PROJECT DESCRIPTION TENANT FINISH IN EXISTING BUILDING  
VACANT LEASE SPACE

Terra Supplements + Superfoods  
Tenant Finish  
1237 NE Douglas Street, Lee's Summit, Missouri

First Floor Plan  
Project number 2022-26  
Date 3-31-22

2 Floor Plan Reflected Ceiling  
1/4" = 1'-0"

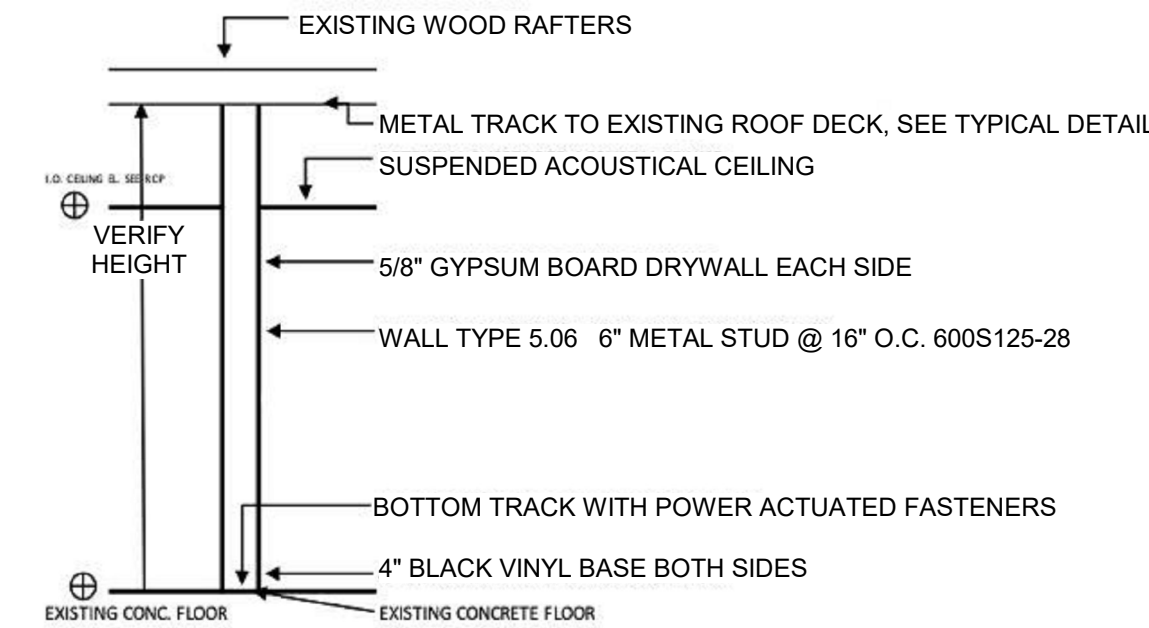
2018 IBC 1209.2 Finish Materials. Walls, Floors and partitions in toilet and bathrooms shall comply with Sections 209.2.1 through 1209.2.4. 2018 1209.2.1 Floors and wall bases. In other than dwelling units, toilet, bathing and shower room floor finish materials shall have a smooth, hard, nonabsorbent surface. The intersections of such floors with walls shall have a smooth, hard, nonabsorbent vertical base that extends upward onto the walls not less than 4 inches. 2018 1209.2.2 Walls and partitions. Walls and partitions within 2 feet of service sinks, urinals and water closets shall have a smooth, hard, nonabsorbent surface, to a height of not less than 4 feet above the floor, and except for structural elements, the materials used in such walls shall be of a type that is not adversely affected by moisture. (See code section for possible exceptions.) 1209.2.3 Showers. (see code for details) 1209.2.4 Waterproof joints. (see code for details) Action required: Provide finish material schedule to demonstrate compliance at water closet and mop sink. If paint is used it must be epoxy based.
